December 22, 2014

RE: Docket Number EERE–2013–BT–STD–0007/ RIN 1904–AC95: Notice of Proposed Rulemaking for Small, Large, and Very Large Air-Cooled Commercial Package Air Conditioning and Heating Equipment

Figure 1. Cost-efficiency curve for small equipment ($\geq 65,000$ and $< 135,000$ Btu/h).⁵

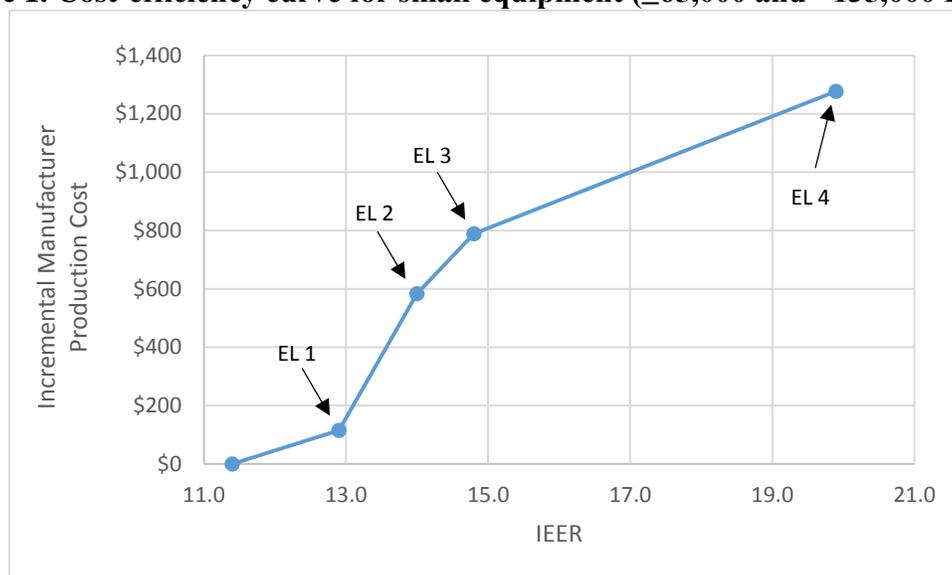
We encourage DOE to ensure that the technology options are properly ordered in developing the cost-efficiency curves. Figures 1 and 2 below show the cost-efficiency curves for small and large equipment, respectively. For both small and large equipment, the slope of the cost-efficiency curve going from EL 3 to EL 4 is significantly less steep than the slope of earlier efficiency increments. For example, for small equipment, the cost of going from EL 1 to EL 2 is almost identical to the cost of going from EL 3 to EL 4, yet going from EL 1 to EL 2 only represents an increase of 1.1 IEER points, while going from EL 3 to EL 4 represents an increase of more than 5 IEER points. Similarly, for large equipment, the increase in IEER going from EL 3 to EL 4 (4.2 points) is larger than the increase in IEER going from the baseline to EL 3 (3 points) and yet the incremental cost going from the baseline to EL 3 is almost four times larger than the incremental cost to go from EL 3 to EL 4.

Appendix²⁷

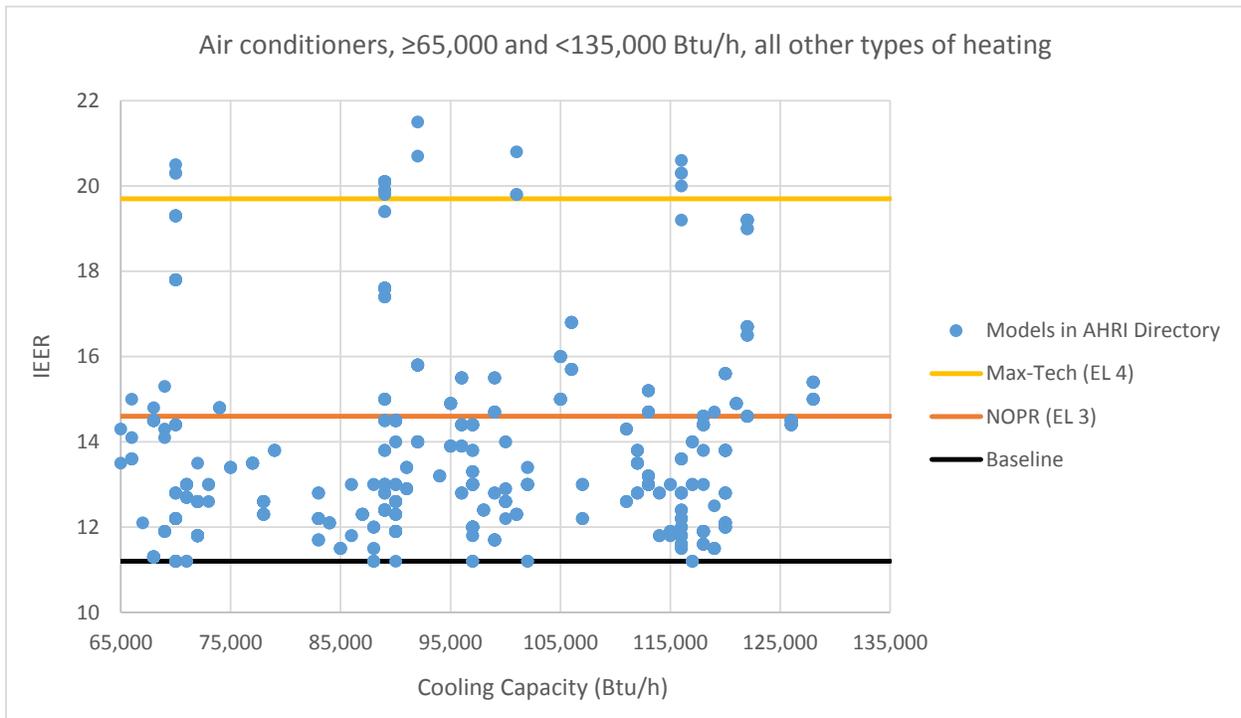
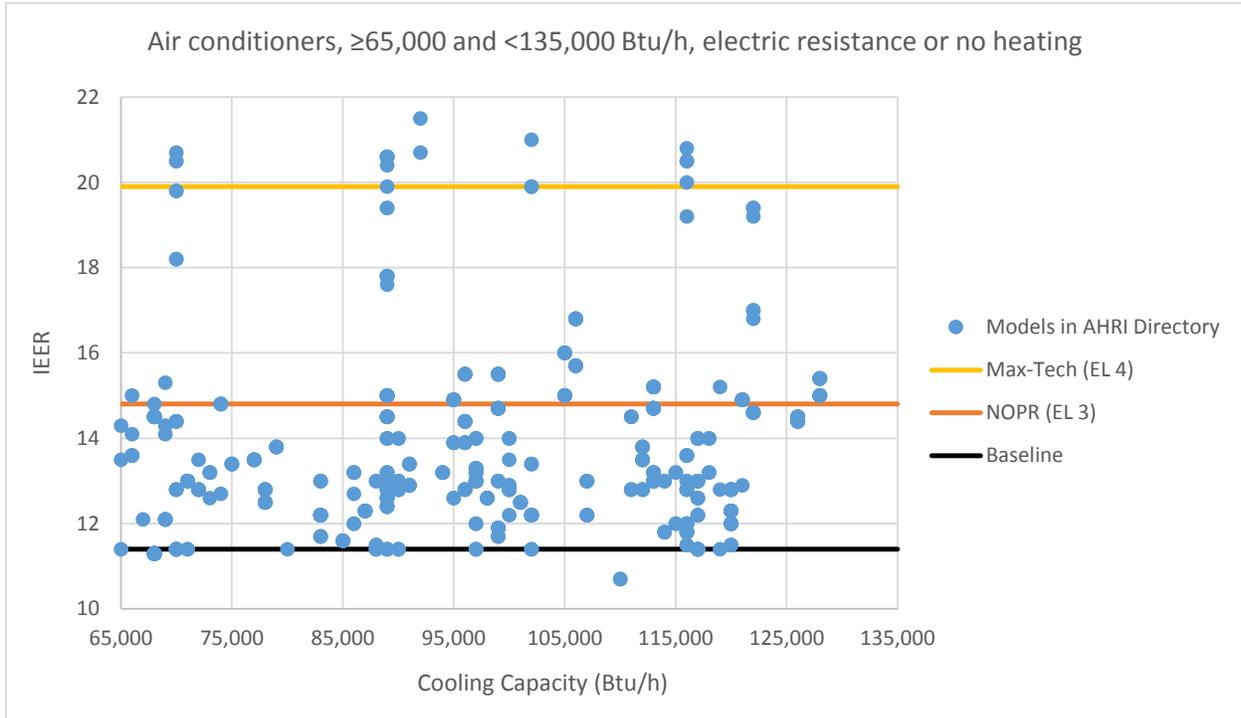
As shown in the graphs in the Appendix, there are models at various IEER levels available between EL 3 and EL 4 across the equipment classes. As noted above, DOE found that the max-tech levels would provide greater life-cycle cost savings for customers than the proposed levels. We would expect that levels between EL 3 and EL 4 would also provide large life-cycle cost savings for customers while achieving greater national energy savings than the proposed standards.

As shown in the graphs in the Appendix, in each equipment class there are multiple models at different capacities with IEER levels that exceed the max-tech levels. We also note that it may be possible to achieve higher efficiency levels than the maximum available efficiency levels since models that represent the maximum available efficiency levels may not incorporate all potential technology options.
